**MAINE DEPARTMENT OF
INLAND FISHERIES AND WILDLIFE**

ADDENDUM NO. 5

**IMPROVEMENTS AT GRAND LAKE STREAM STATE FISH HATCHERY
GRAND LAKE STREAM, MAINE**

BGS PROJECT NO.: 3289-14

SHEET
03S-102

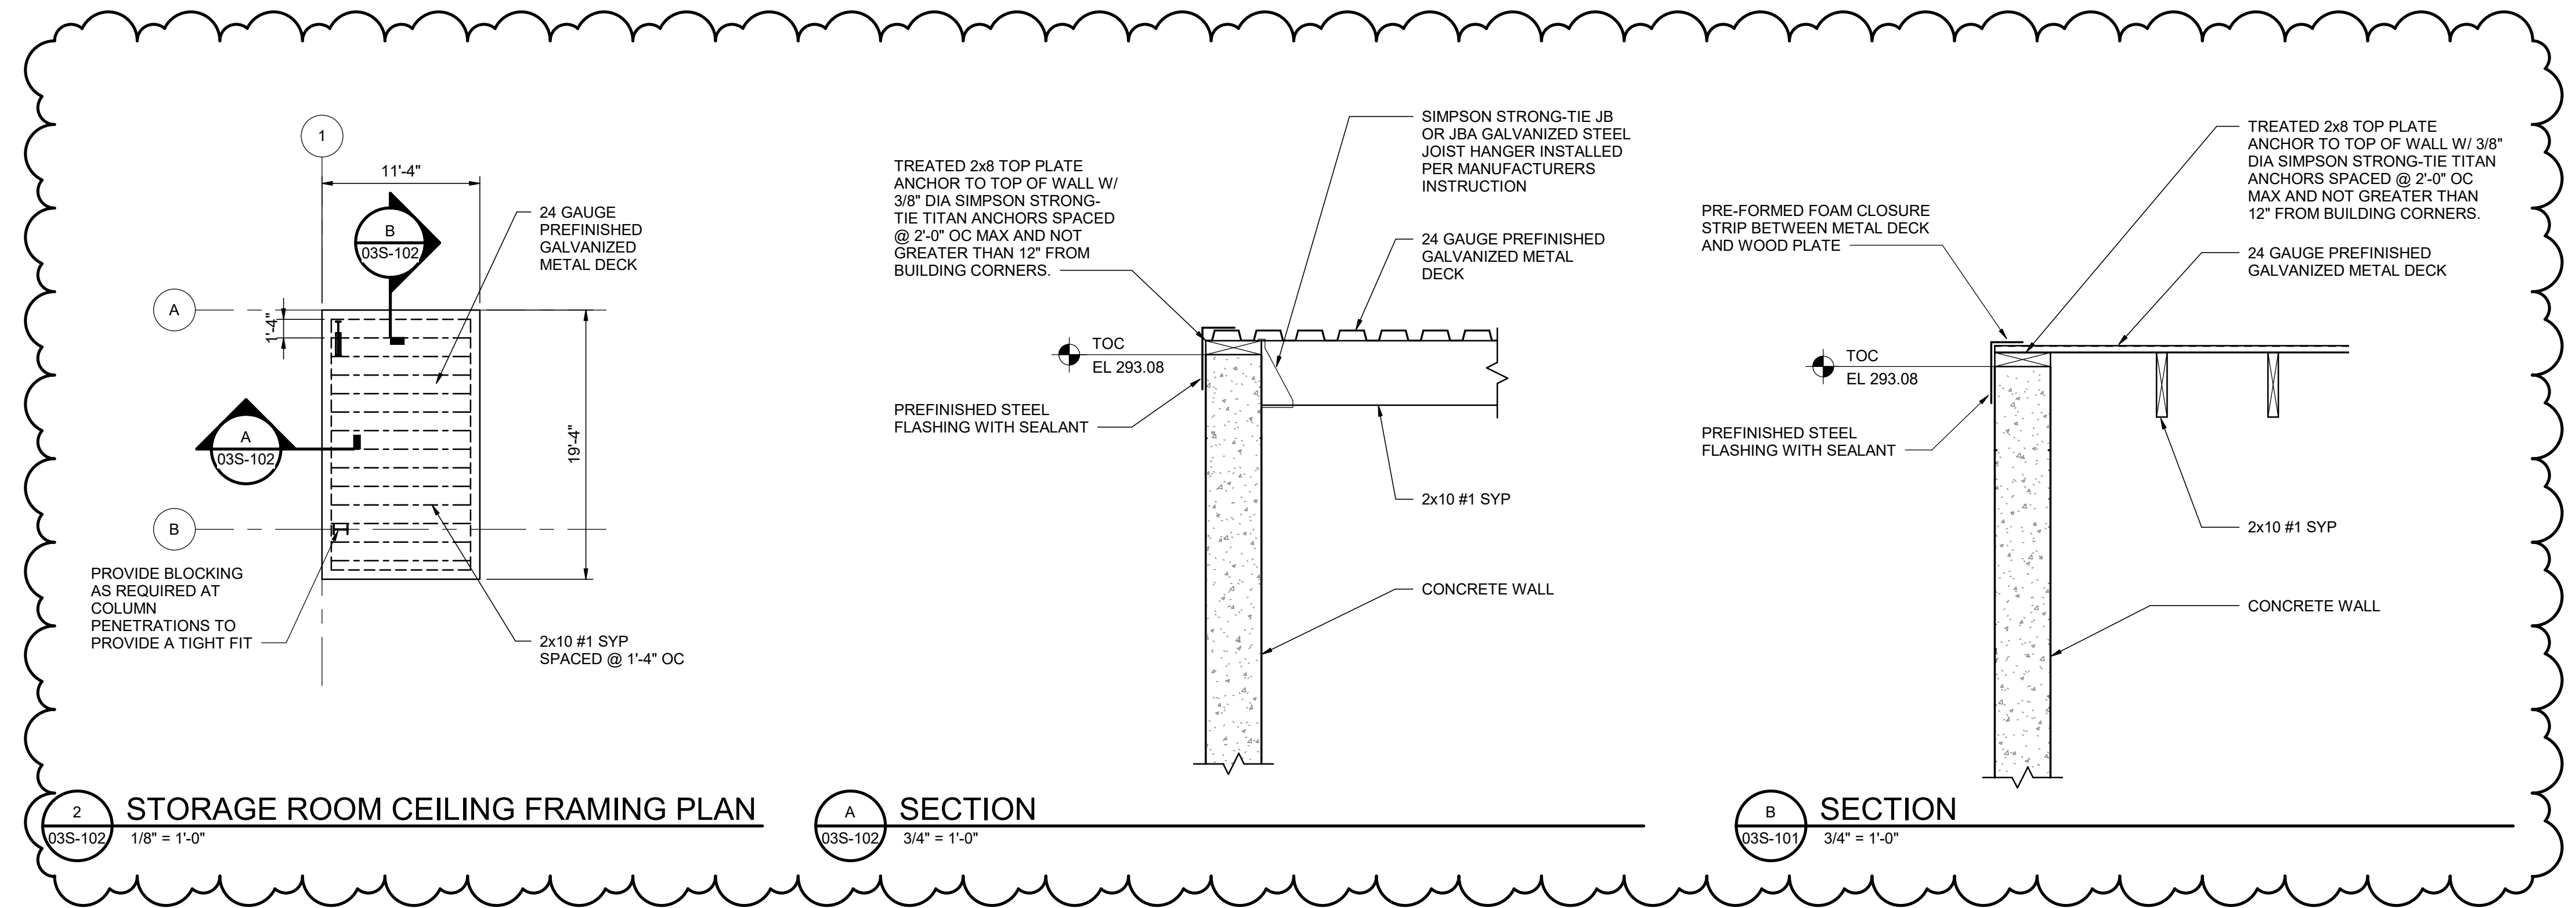
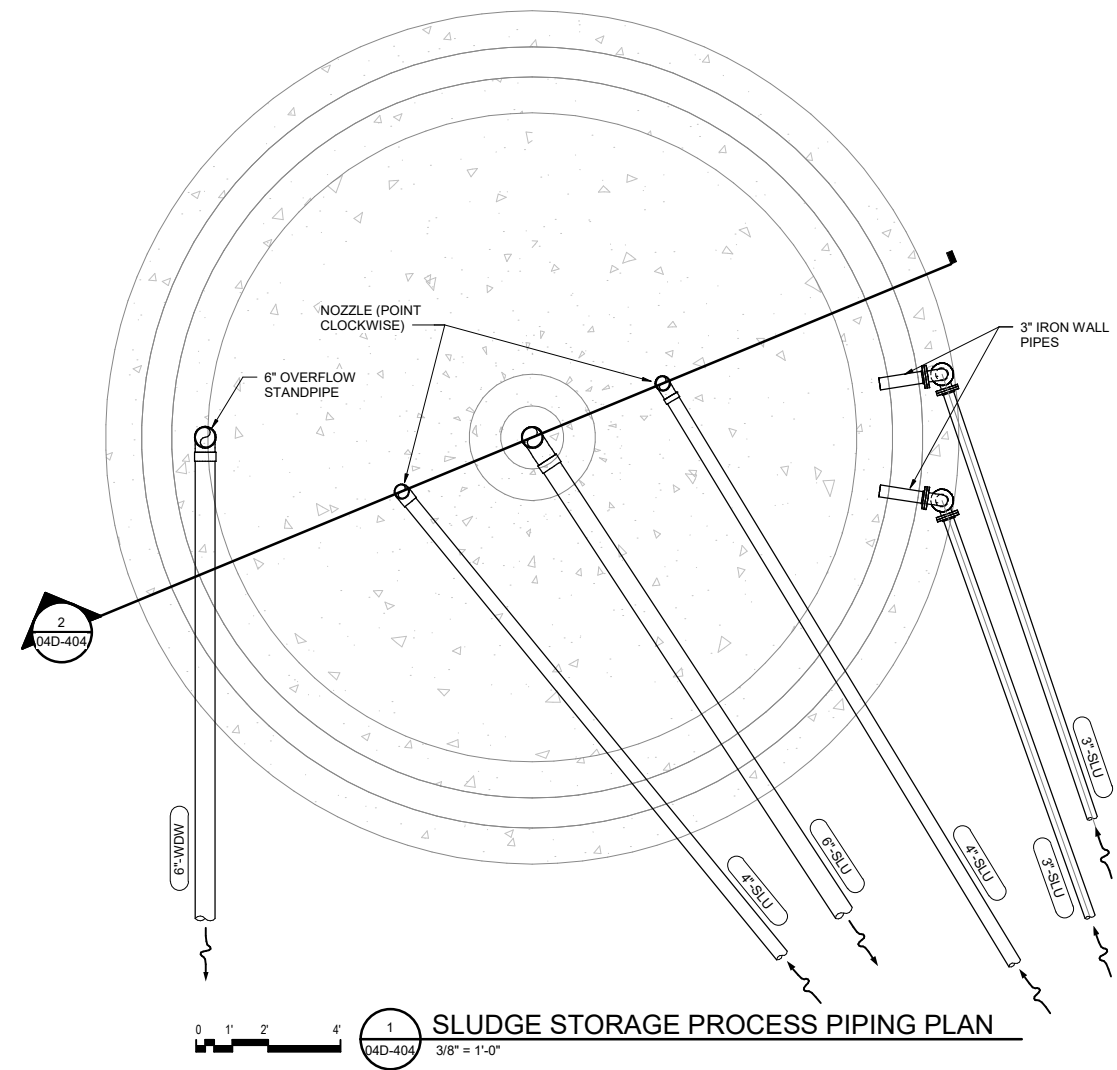
- 10. SHEET 02S-102: UPPER PAVILION FRAMING PLAN**
UPDATE: Sheet was updated to add additional details for storage room ceiling. See attached drawing.
- 11. SHEET 03S-102: LOWER PAVILION FRAMING PLAN**
UPDATE: Sheet was updated to add additional details for storage room ceiling. See attached drawing.

SHEET
04D-404

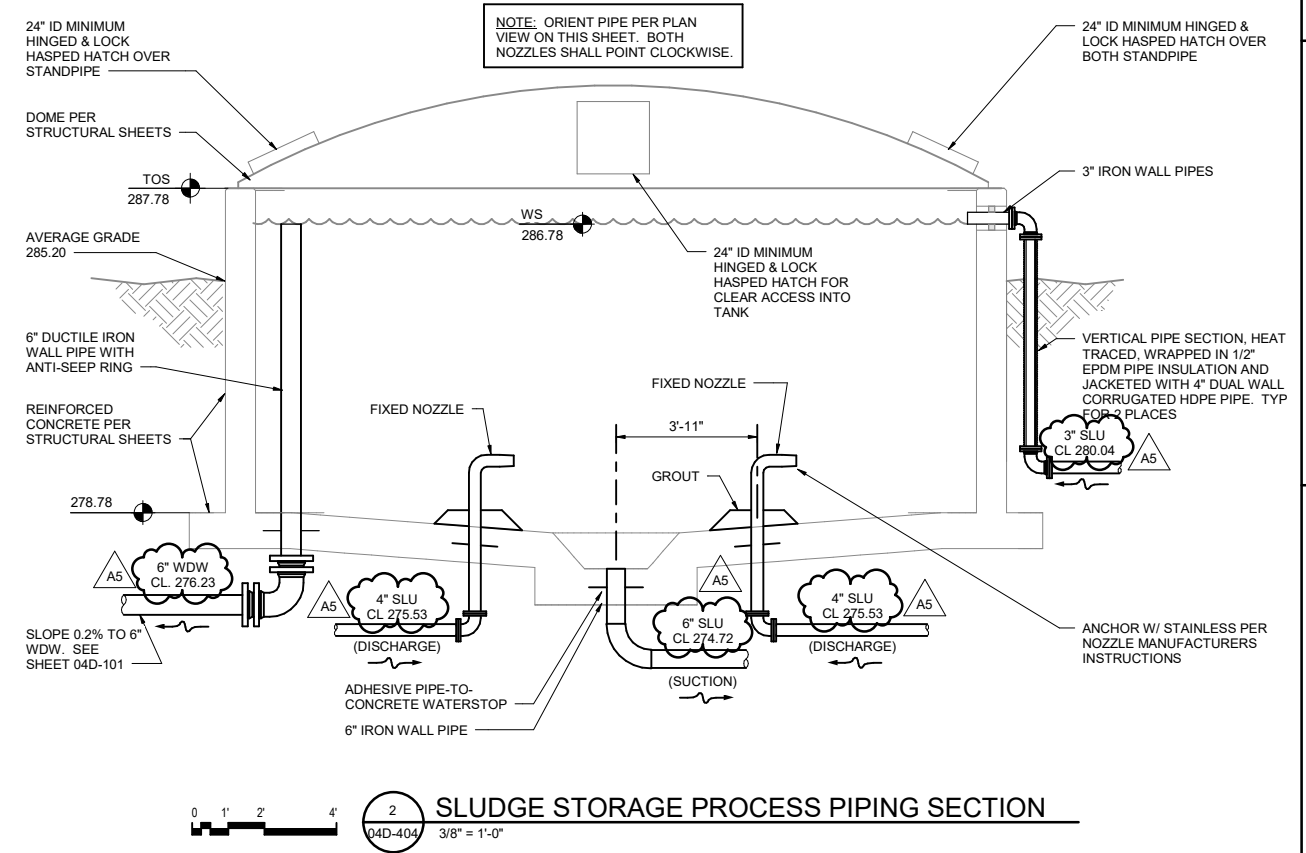
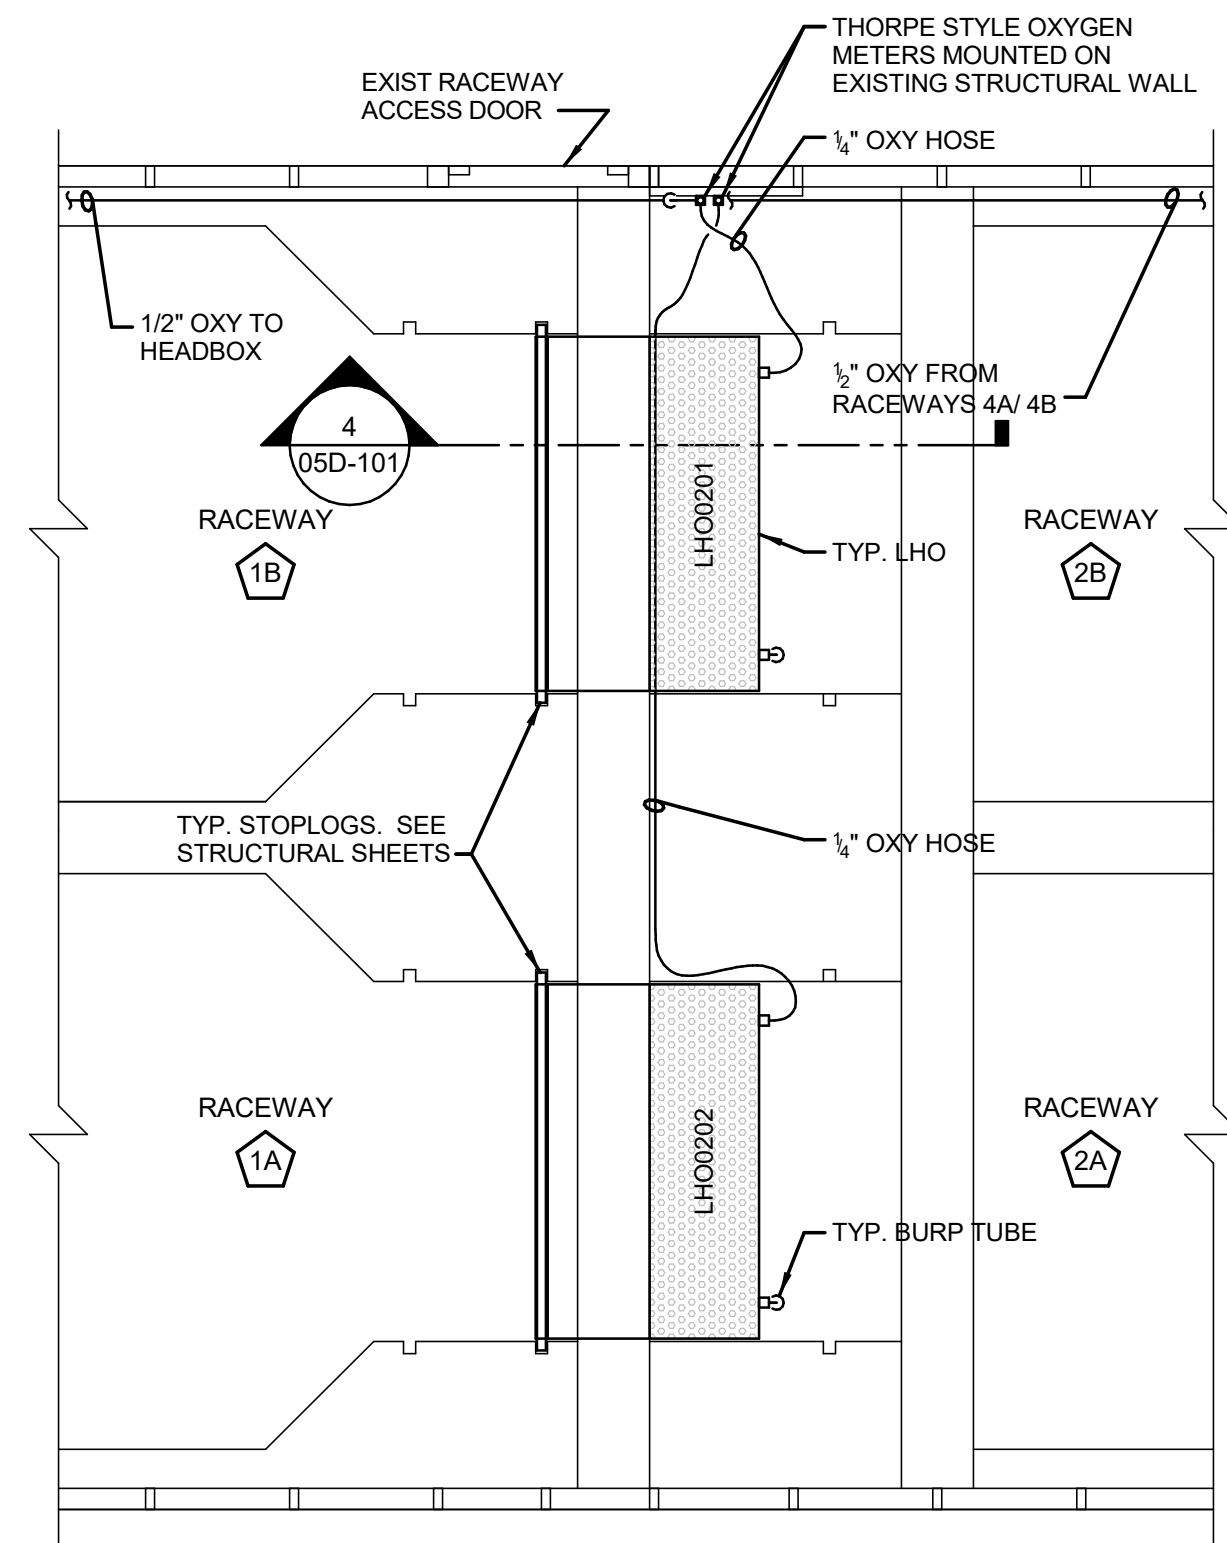
15. SHEET 04D-404: SLUDGE STORAGE PROCESS PIPING PLAN & DETAILS, SECTION 2

REPLACE: "24-IN ID MINIMUM HINGED & LOCK HASPED HATCH FOR CLEAR ACCESS INTO TANK" WITH "30-IN X 30-IN MINIMUM HINGED & LOCK HASPED HATCH FOR CLEAR ACCESS INTO TANK" See attached drawing.

EXISTING RACEWAYS LHO PIPING PLAN AND SECTIONS

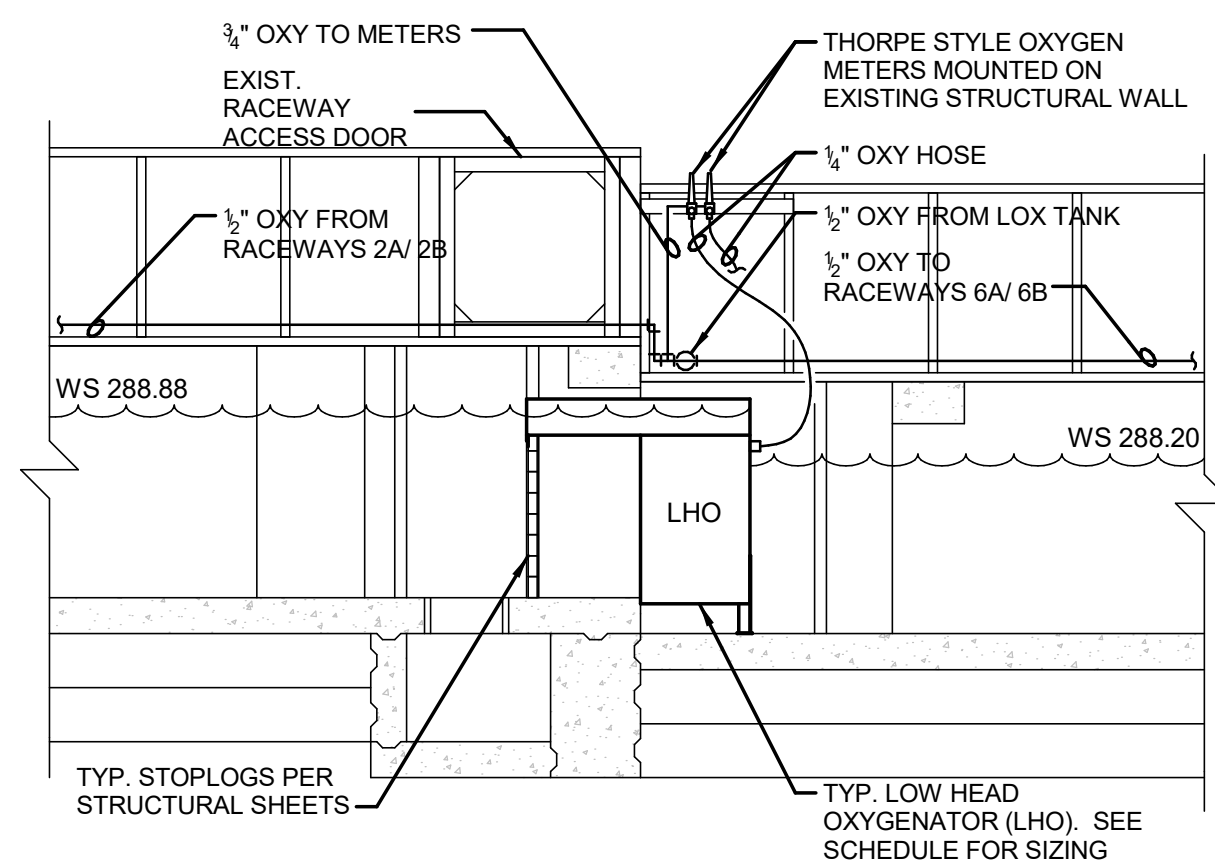
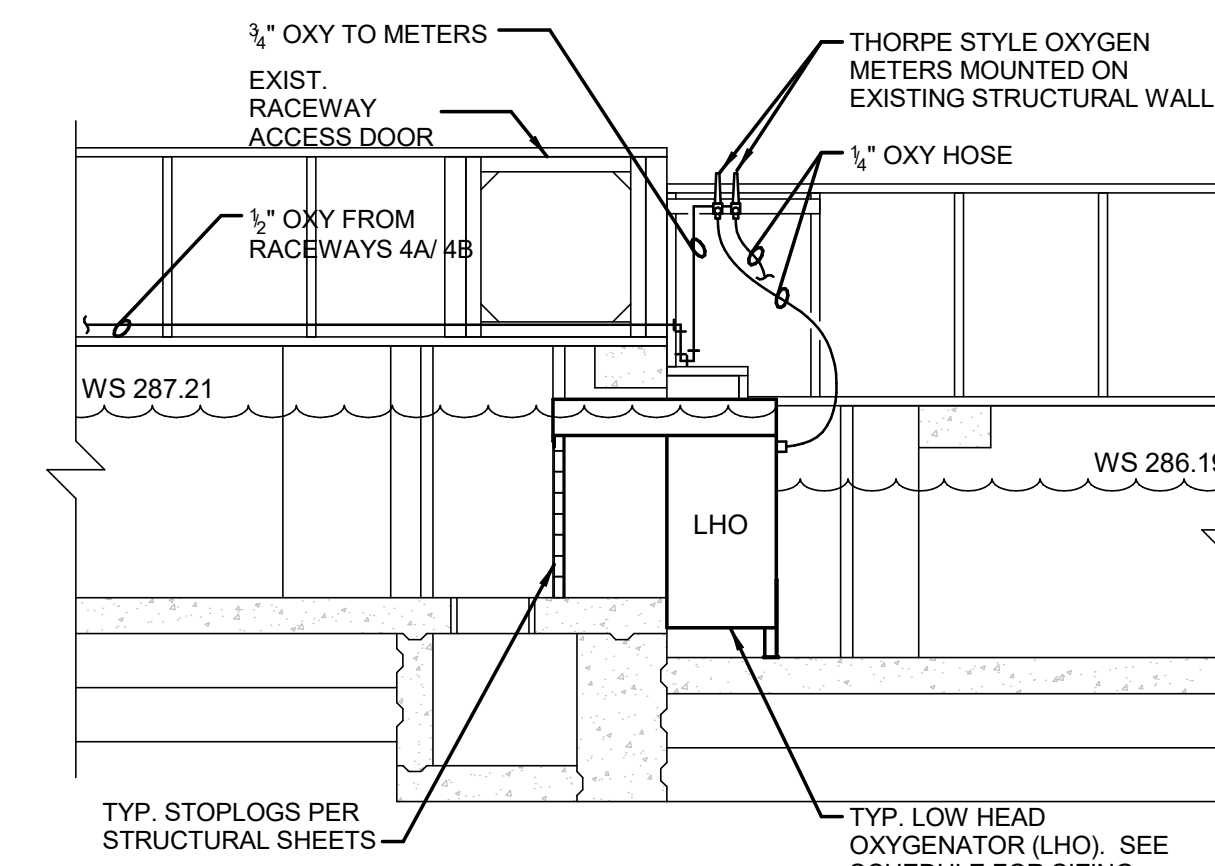
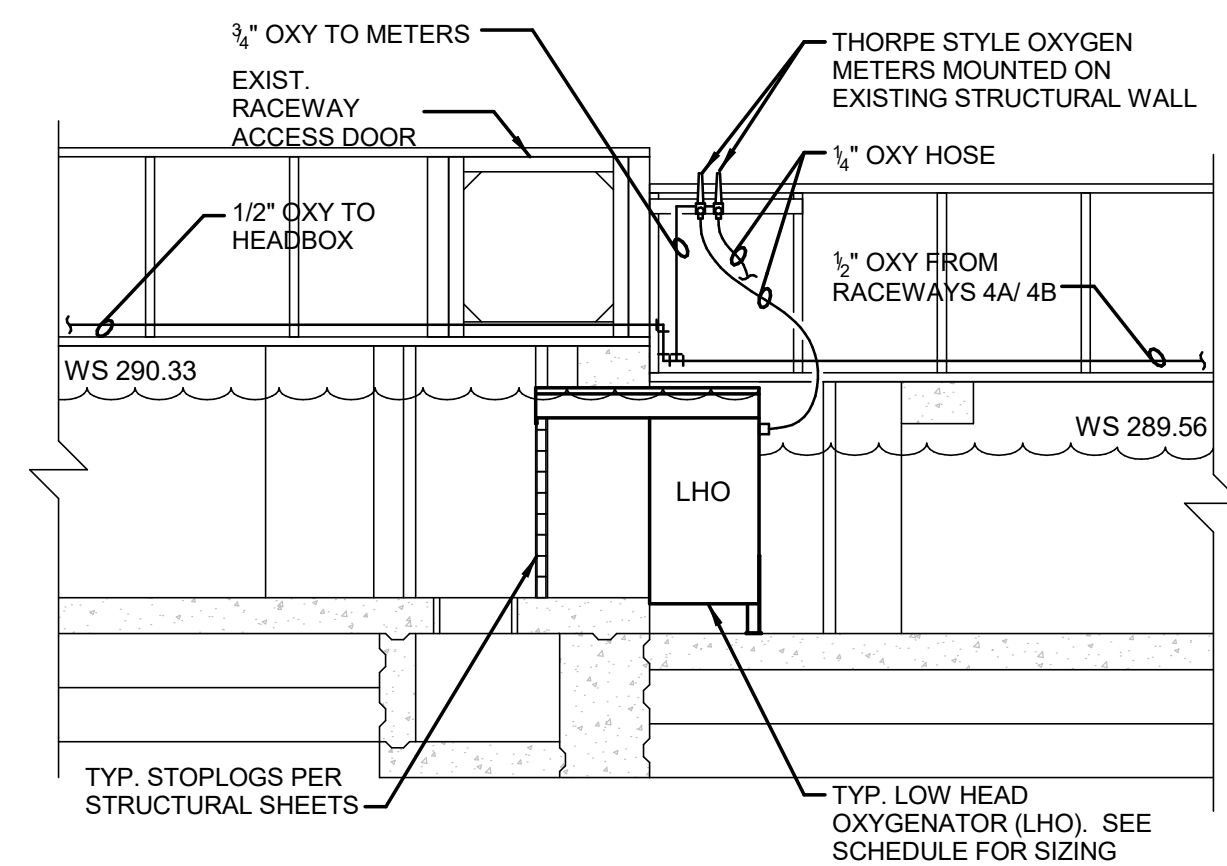
- 14. SHEET 05D-101: EXISTING RACEWAY LHO PIPING PLAN AND SECTIONS**
 - a. **UPDATE:** SECTION 6, REPLACE: “TYPICAL STOPLOGS PER STRUCTURAL SHEETS” with “FOUR 2 INCH X 6 INCH X 63 INCH X ¼ INCH ALUMINUM C-CHANNELS AND ONE 2 INCH X 3 INCH X 63 INCH ALUMINUM C-CHANNEL”. (These are NOT metal stop log systems as described in Specification Section 40 60 05.)

- b. **UPDATE:** SECTION 5, REPLACE: “TYPICAL STOPLOGS PER STRUCTURAL SHEETS” with “FOUR 2 INCH X 6 INCH X 63 INCH x ¼ inch ALUMINUM C-CHANNELS AND ONE 2 INCH X

- 3 INCH X 63 INCH ALUMINUM C-CHANNEL". (These are NOT metal stop log systems as described in Specification Section 40 60 05.)
- c. **UPDATE:** SECTION 4, REPLACE: "TYPICAL STOPLOGS PER STRUCTURAL SHEETS WITH FIVE 2 INCH X 6 INCH X 63 INCH x ¼ inch ALUMINUM C-CHANNELS". (These are NOT metal stop log systems as described in Specification Section 40 60 05.)
- d. **ADD:** TYPICAL ¾" ISOLATION VALVE ON ¾" OXYGEN LINE, UPSTREAM OF OXYGEN METERS.
- e. **ADD:** Typical 2' dimension between floor and oxygen flow meters. See image below and attached drawing.
